Docket No. 52-001

SUBJECT: FINAL REPORT TO DOCUMENT THE DISPOSITION OF THE IIRG COMMENTS
ON THE GE NUCLEAR ENERGY (GE) ADVANCED BOILING WATER REACTOR
(ABWR) INSPECTIONS, TESTS, ANALYSES, AND ACCEPTANCE CRITERIA
(ITAAC)

INDEPENDENT REVIEW GROUP COMMENTS REQUIRING DISPOSITION BY GE

A. Figure 2.6.1 CDM

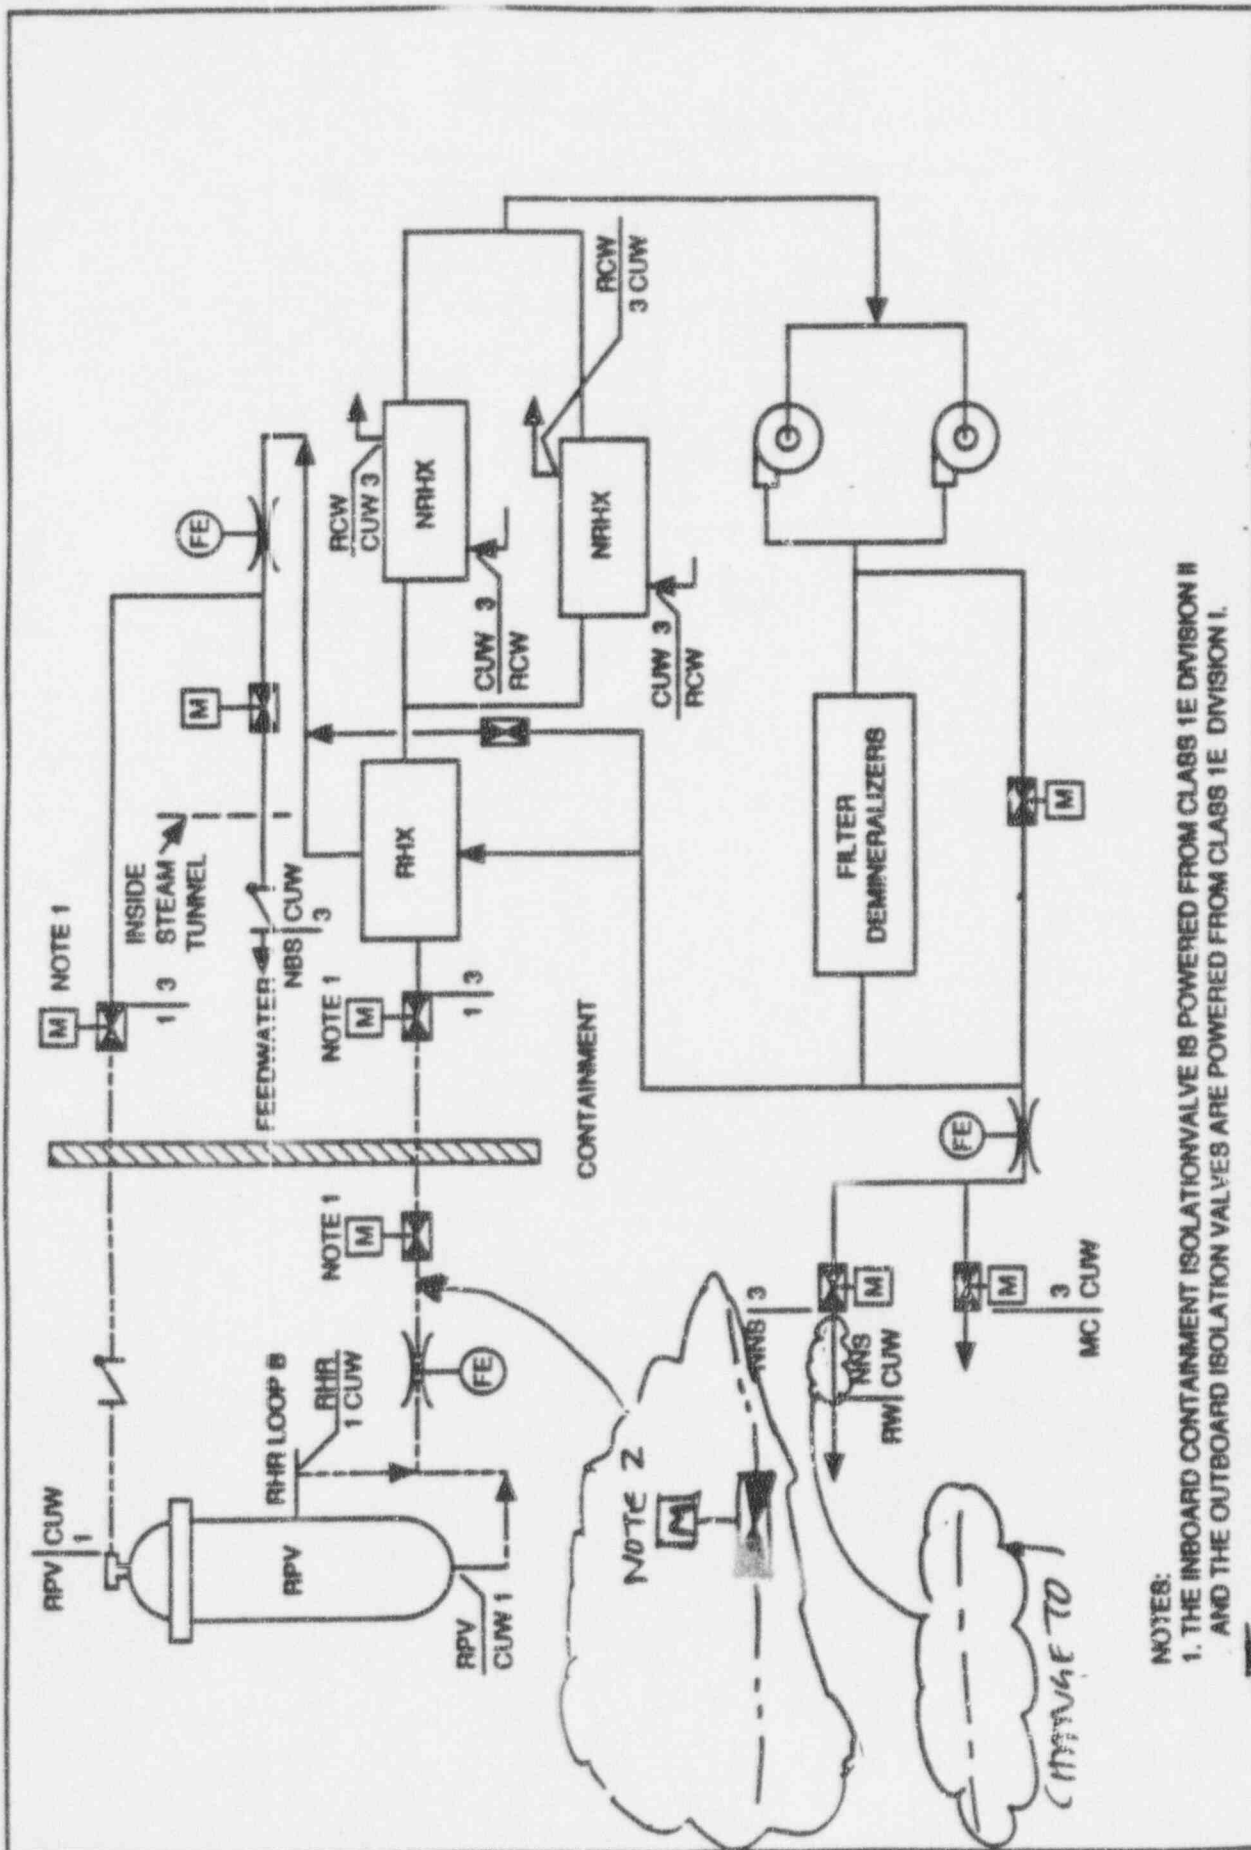
ADD ACRONYM MC
TO APPENDIX B.

FROM REVERSED
NEED TO SHOW THIS
FLOW RESTRICTOR
ALSO ADD
SYMBOL TO
PID ALONE
1-7-1

Need to start
Flow Restriction
AND ADD
SYMBOL TO
P&ID ABOVE
1-7-1

- a) Leave the FE Venturi as-is. This is common use throughout the BWR and represents a dual-function flow measuring device based on a Venturi and a flow restriction device. *f SYMBOL IDENTIFIED IN LEGEND FOR CDM AS A FLOW RESTRICTION ALSO STATED IN DD. SSAR SYMBOL FOR VENTURI ALSO REPRESENTS FLOW RESTRICT.*
- (Continued on next page...)

Figure 2.6.2 Fuel Pool Cooling and Cleanup System

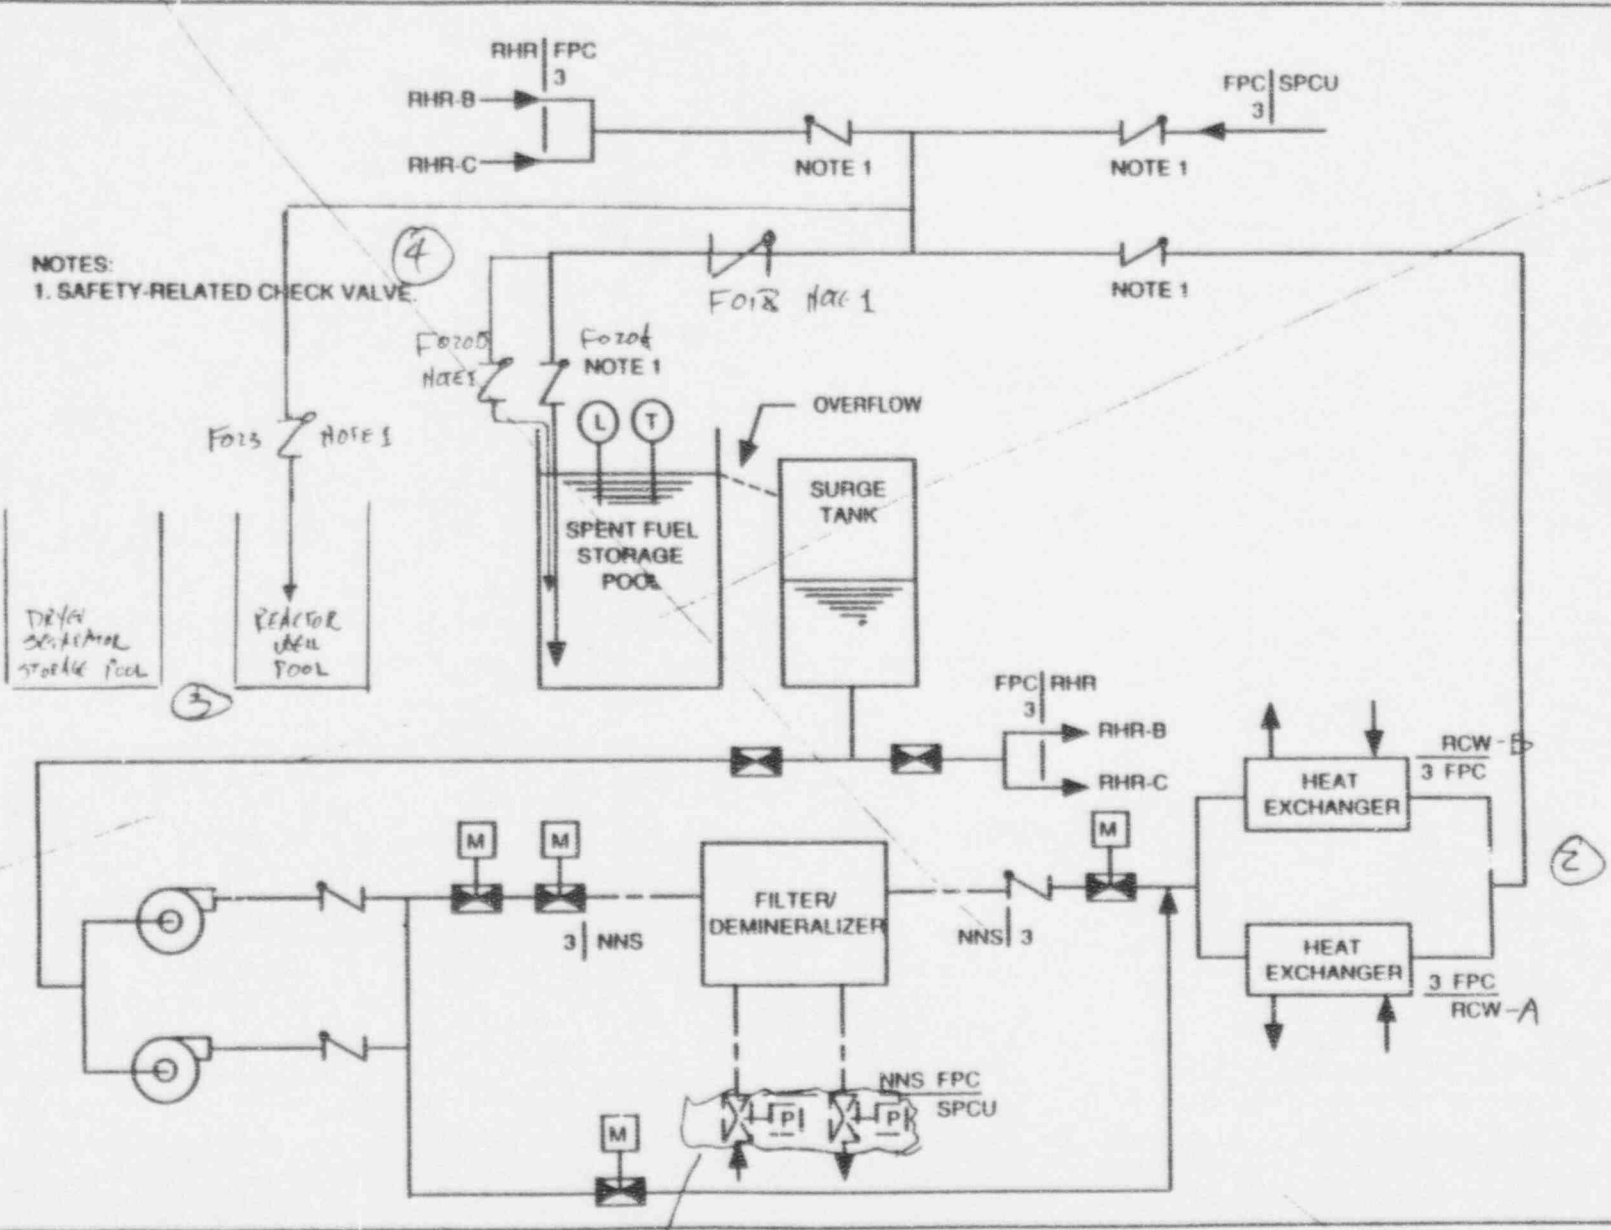
Figure 2.6.2 phantom valves: either show phantom valves at all system interfaces, or delete those that are shown.

5 EITHER SHOW PHANTOM VALVES AT ALL ACTION INTERFACES, OR DELETE THESE.

Valves F020 A and B are check valves on the branch lines downstream of F018. These valves are not shown because the CDM drawing need not be shown to this level of detail at that point. Should the specific design at the COL stage be changed to accommodate a single branch line to the spent fuel pool rather than two branch lines, as currently shown in SSAR Fig. 9.1-1 (sh 1 of 3), rulemaking would have to be instituted to change the CDM, which would be counterproductive.

Figure 2.10.2b Main Condenser Evacuation System

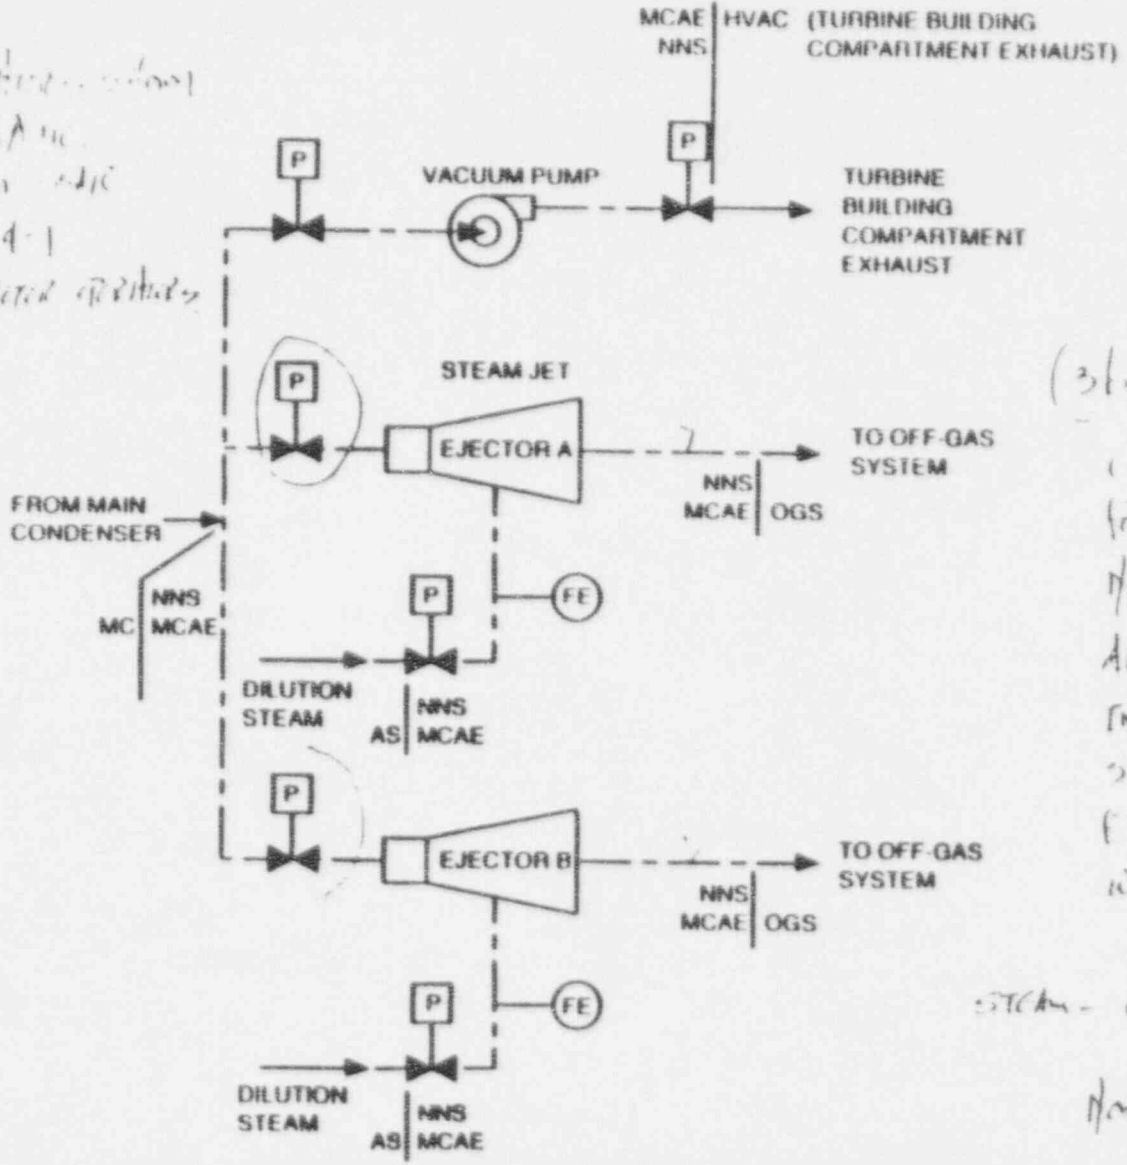
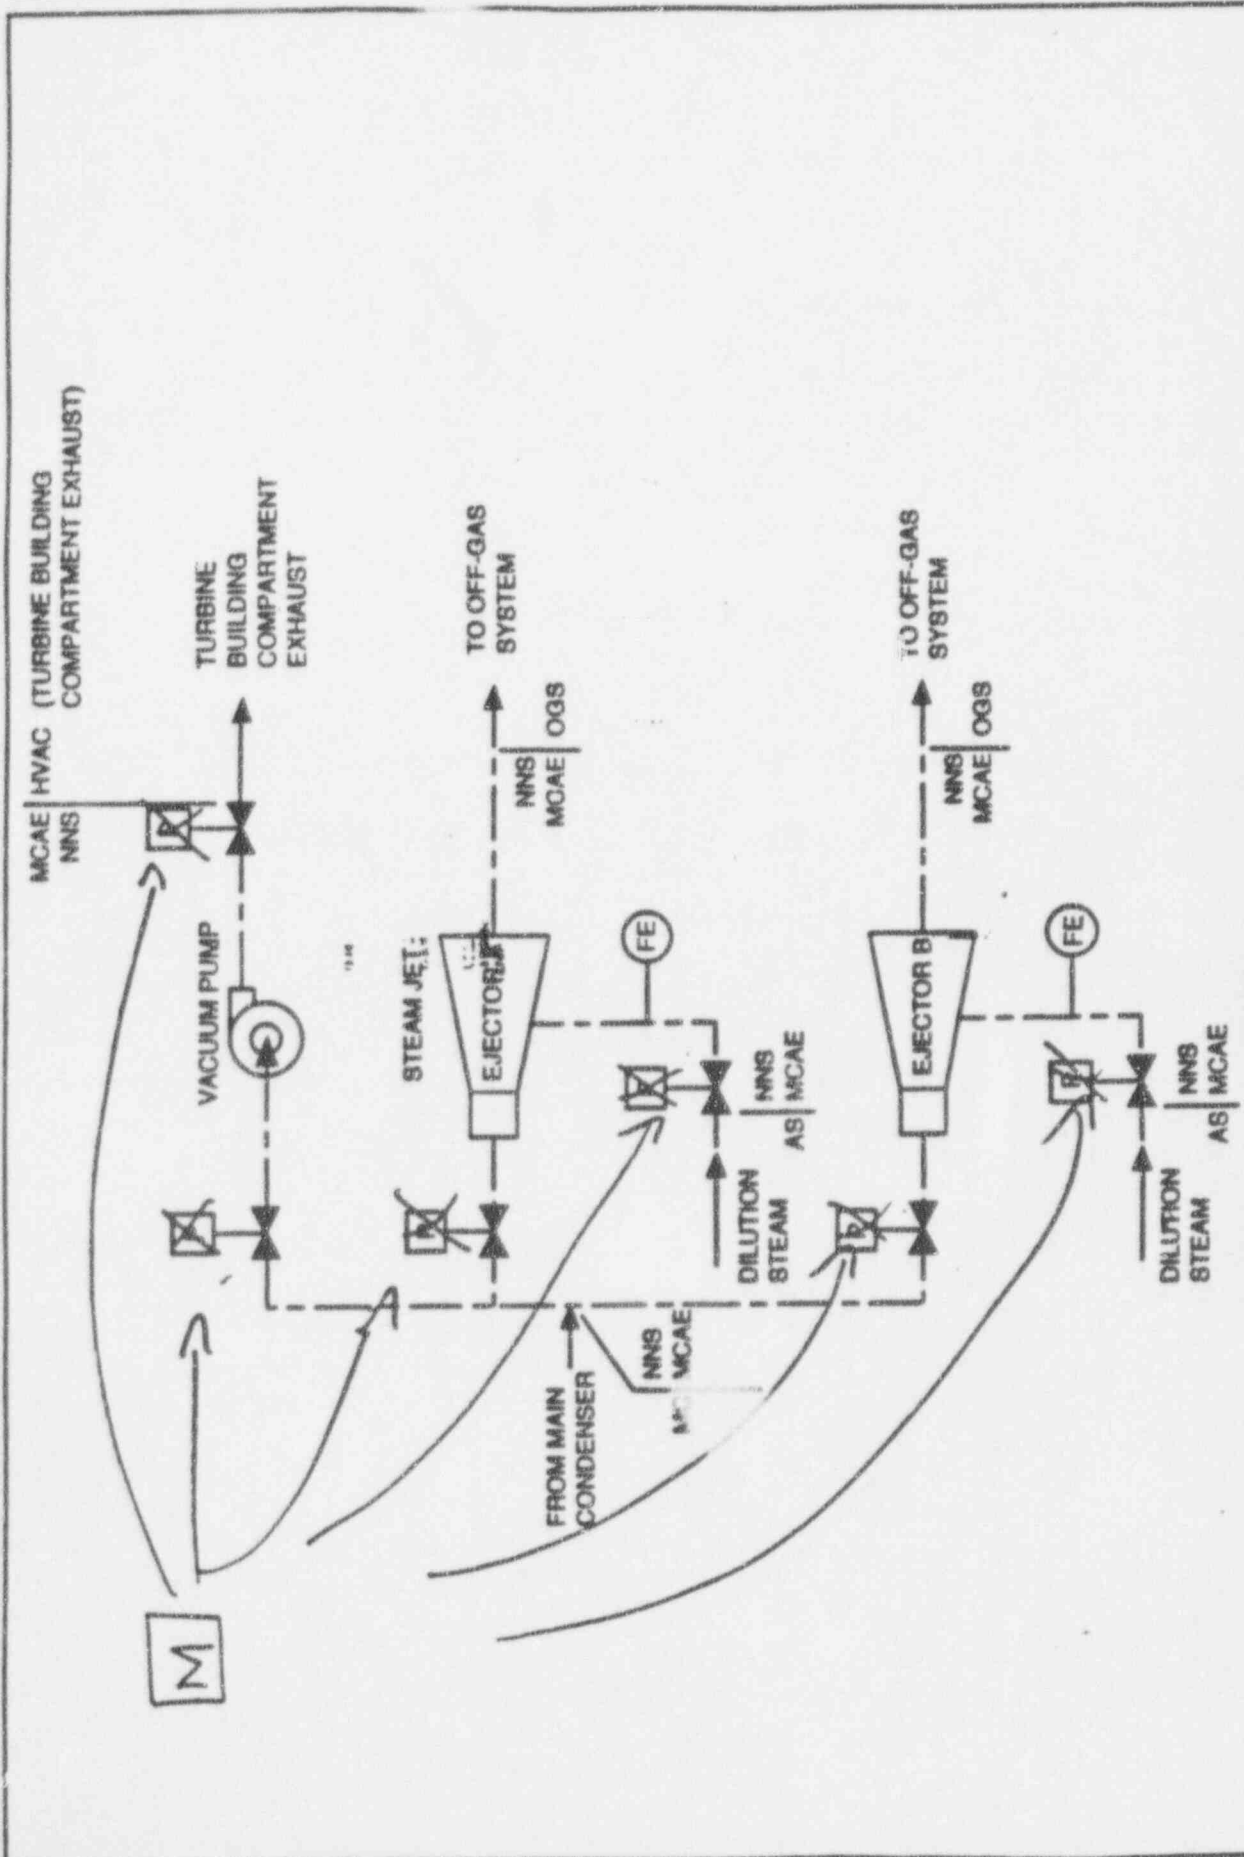
Valve operators shown are pneumatic, whereas on SSAR figure 10.4-1, they are motor operators. Reconcile the type of valve operators used for the valves on piping from SJAES to inlet of vacuum pump as shown in ITAAC figure 2.10.2b.

Page 2.10.2-6, table 2.10.2b, item 2: The acceptance criteria requires the SJAE discharge valves to close. These valves are not shown on figure 2.10.2b.

④ These valves are not shown on figure 2.10.2b.

- (a) GE will make consistent as described in the enclosure.
- (b) No change needed since ITAAC Figure 2.10.2b does not have to show stage of SJAES.

(Task Group:) Show SJAES discharge valves on ITAAC figure 2.10.2b as shown in SSAR figure 10.4-1. Also, explain why one of the SJAE discharge goes to "offgas-A" but not diverted to "turbine compartment exhaust system" in certain condition in SSAR figure 10.4-1 (see ITAAC figure 2.10.2b).

Figure 2.10.9 Turbine Gland Seal System

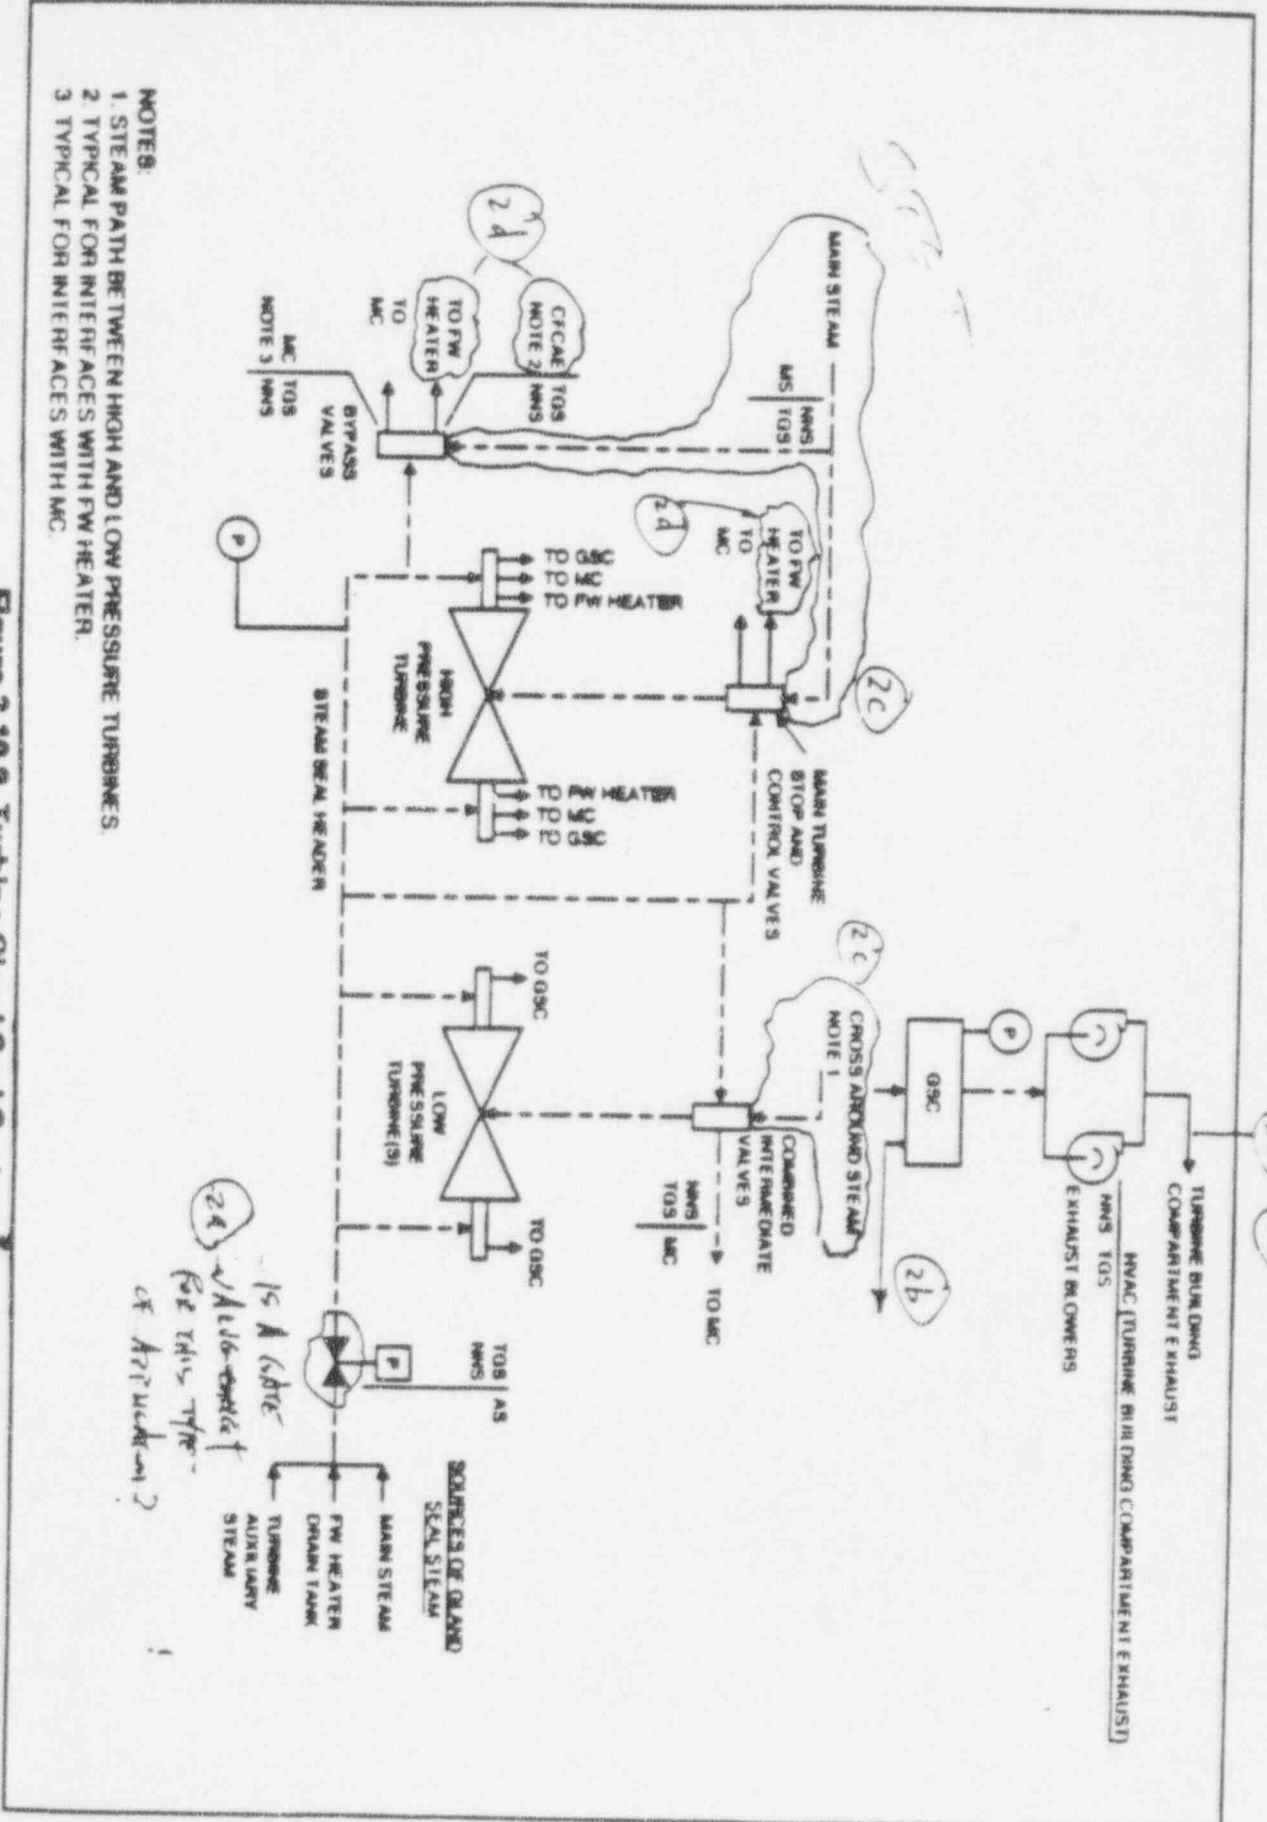
- a. The sealing steam pressure regulator is shown as a gate valve. Is this the correct valve type for this application?
- b. A drain connection to the gland steam condenser is required.
- c. Delete the piping for main steam and the cross around steam to the main turbine. They are not relevant to this diagram. Retain note 1 if "CROSS AROUND" appears elsewhere on diagram, delete is otherwise.
- d. Steam leaving the main turbine stop and control valves and the bypass valves are shown being directed to the feedwater heater. On SSAR Figure 10.4-2, they are directed to the cross around piping. Resolve this discrepancy. Delete note 2 if "FW HEATER" is deleted.
- e. Add radiation monitor at the exhaust blower discharge. This item is discussed in Section 2.3.1.

- a. ITAAC figure symbol is meant for any type of valve, and therefore no change is needed in ITAAC Figure 2.10.9.
- b. No such details are needed in Tier 1 material for non-safety system such as this TGS.
- c. TGS is a non-safety system. However, GE shows additional interfaces to understand the TGS which encompasses the several aspects of steam and power conversion system components and/or function(s). Therefore, no change is needed.
- d. GE agreed to make changes as described in the enclosure.
- e. All radiation monitoring is part of "PRM System" and it does not have to be shown figuratively in ITAAC figure.
